JOINT REGIONAL PLANNING PANEL
Hunter and Central Coast

Panel Reference	2016HCC005
DA Number	DA/2122/2015
Local Government Area	Lake Macquarie
Proposed Development	Hospital Alterations and Additions
Street Address	42 Fairfax Road Warners bay
Applicant/Owner:	Erilyan Pty Ltd/ HCOA Operations Aust Pty Ltd
Number of Submissions	Eleven
Recommendation	Approval, subject to conditions
Regional Development Criteria	Private Infrastructure and Community facility that has a capital investment value of more than \$5 million.
List of all relevant s79C(1)(a) matters	State Environmental Planning Policy (infrastructure) 2007 State Environmental Planning Policy No. 55 – Remediation of land State Environmental Planning Policy No. 71 – Coastal Protection Lake Macquarie Local Environmental Plan 2014 Lake Macquarie Development Control Plan 2014
List all documents submitted with this report	Attachment 1 – Proposed Conditions Attachment 2 – Plans of Development Attachment 3 – Clause 4.6 Variation – Height of Buildings

Report by	Glen Mathews, Development Planner, Lake Macquarie City Council

Figure 5 - North Elevation

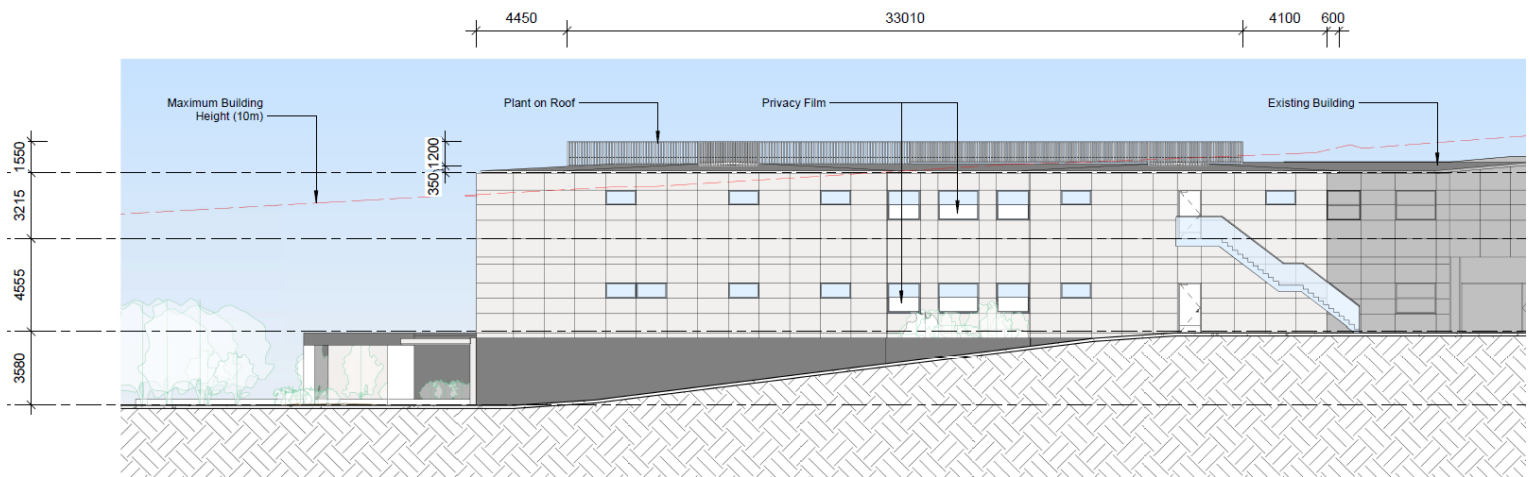
Planning Comment: The proposal is for alterations and additions to the Warners Bay Private Hospital. The proposed development will exceed the maximum building height prescribed by Clause 4.3 height of buildings by 2m or 20% having an overall building height of 12m. The building height is measured from existing ground level to the top of the proposed plant screening on the roof. The plant screen is 1.2m high and set in 4.05m from the edge of the building or 4.65m from the edge of the roof, including eaves.

Figure 6 - Shadow Diagram

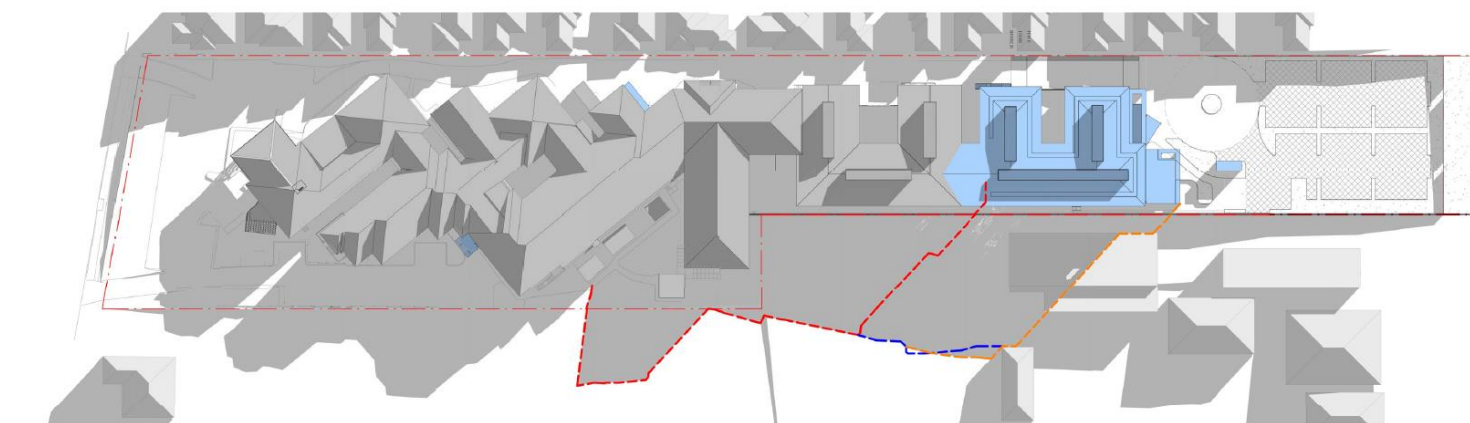
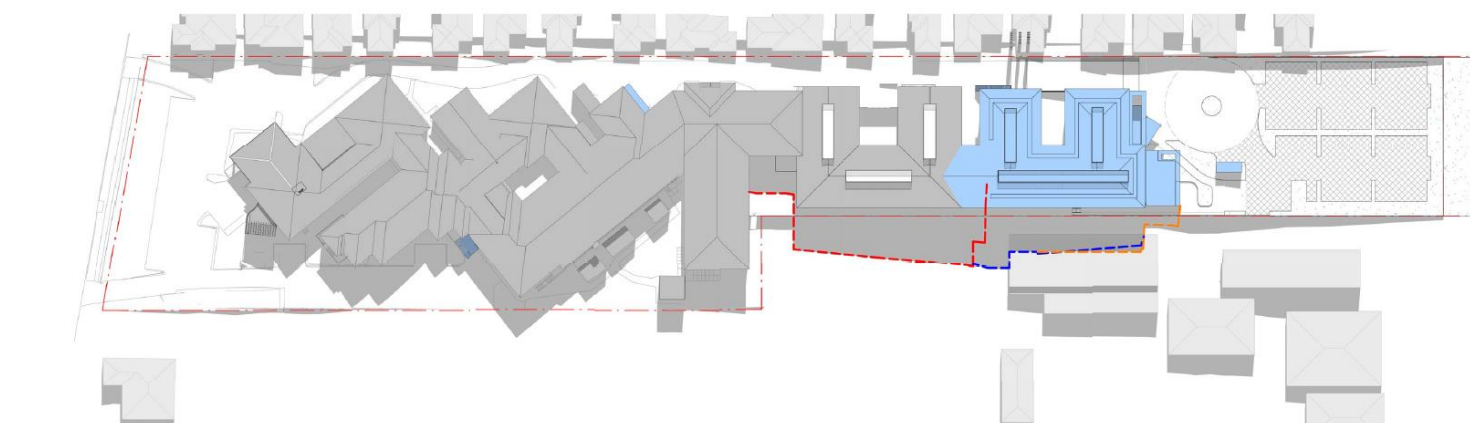
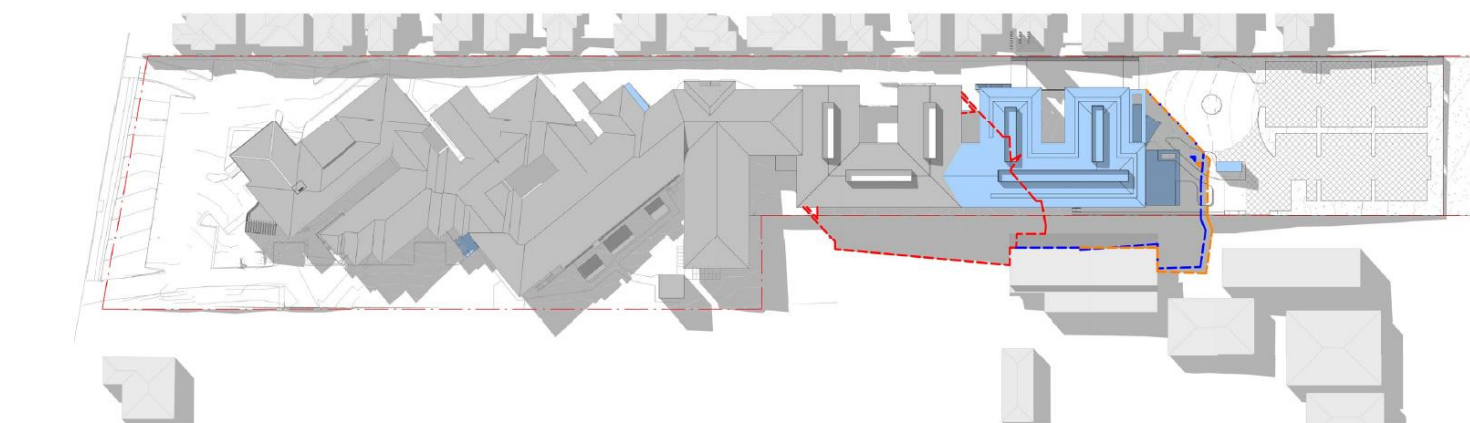
The written request to vary the development standard has included shadow diagrams which represent the difference between over shadowing from a fully compliant development and development proposal. Figure 6 demonstrates the difference in overshadowing produced by the development as minor and negligible in terms of solar impact on adjoining land uses.

Figure 7 - Area exceeding maximum building height

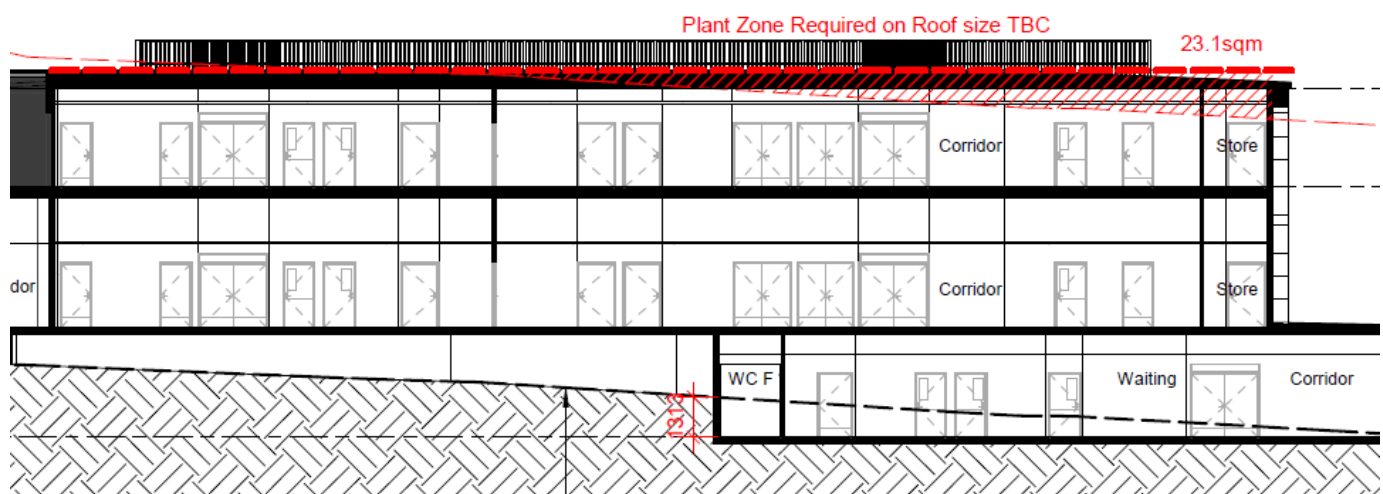
The exceedence of the 10m height limit is associated with all plant and screening centrally located upon the proposed roof and an area of 23.1m² viewed from the southern elevation as demonstrated in figure 7. All plant located on the roof is suitably setback from the edge of the roof and will not adversely impact views, solar access or visual privacy of the existing locality. Figure 6 above demonstrates the additional solar impact from the area exceeding the maximum height and does not show an unacceptable level of overshadowing or significantly reduce the ability of adjoining development to achieve solar access from what would be provided by a development with a maximum height of 10m.

The variation of the control allows the foot print of the proposal to be consolidated to provide the ability to have all APZ's contained within the subject site and maintain suitable buffers to EEC contained within the eastern portion of the site, while maintaining a suitable yield of beds and ancillary facilities from the proposal.

Figure 9 - Labelling of floor levels

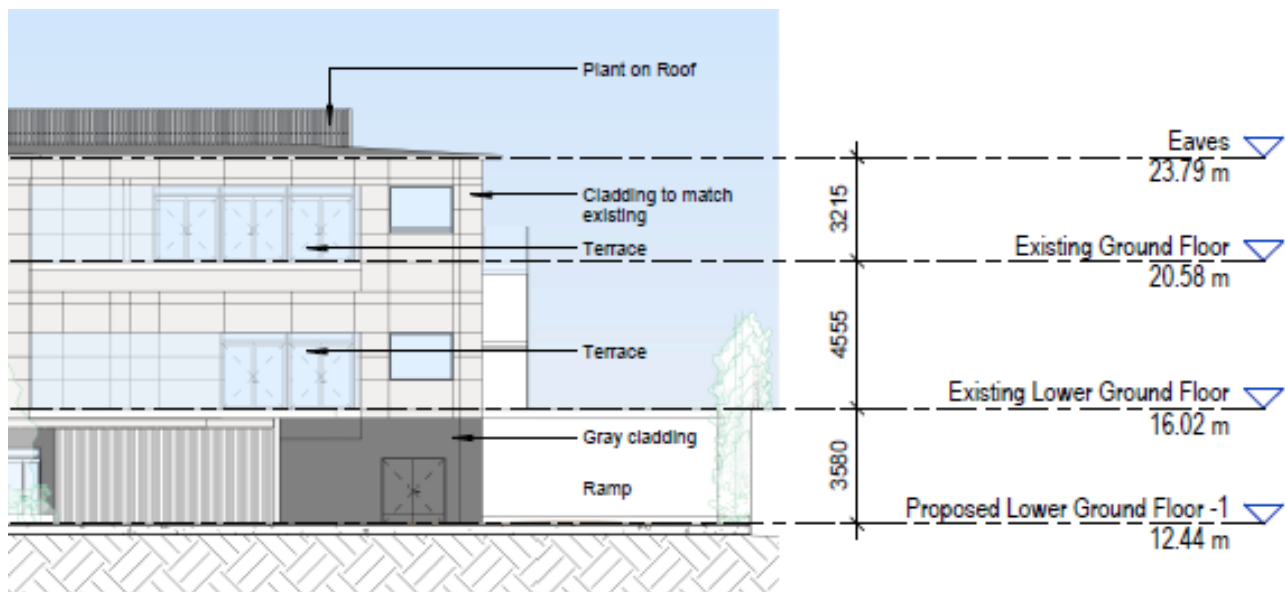
To the south the structure presents as a large unbroken form, providing an additional building element of 41m length and up to 11.35m in height plus roof area. The bulk and continuous form is complimented by providing a dark grey cladding to the lower ground level 1 and inclusion of 7 large window opening in this level. Lower ground and ground floors are a lighter colour cladding which is consistent with the existing hospital building. A large window is provided to each bedroom, with a total of 11 windows to incorporated into each floor along the elevation to provide a break in materials. A minimum side setback of 2.8m for the lower ground level 1 provides adequate area for provision of landscaping and deep soil planting to soften the bulk of the built form. It is also noted that as the development extends back into the site, the site narrows from 65m to 41m, which limits the potential to significantly articulate the built form. As such a combination material use, provision of glazed opening and provision of landscaping has been utilised to reduce the bulk of the building presented to the south. These variations have also been provided to the norther elevation which also includes articulation of built form is provided with a maximum unbroken length of 19.56m. It is considered that the additional articulation helps to reduce the impact of building presented to development north of the subject site.

The eastern elevation provides suitable articulation, with Lower ground floor 1 extending toward the rear boundary and both lower ground and ground floor incorporating external terrace areas. There are variations in building materials and a suitable number of openings to provide visual relief.
